## T43016 / T43017

VAG 1.8 Petrol

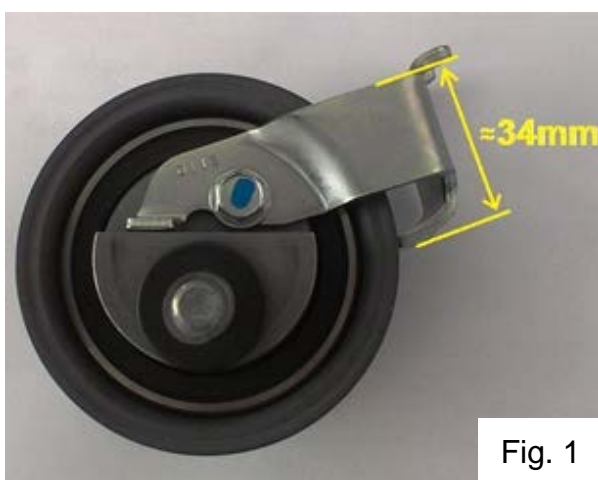
Tensioners T43016 (Fig. 2) and T43017 (Fig. 1) are used in combination with Timing Belt 5491XS.

Although both tensioners look identical at first sight, they are not interchangeable.

The difference is to be found in the orientation of the attacking arm, which differs by 3°.

The T43016 and T43017 are not interchangeable. Failure to use the appropriate kit and tensioner for this application will lead to incorrect tension. Premature belt failure and severe engine damage are inevitable consequences.
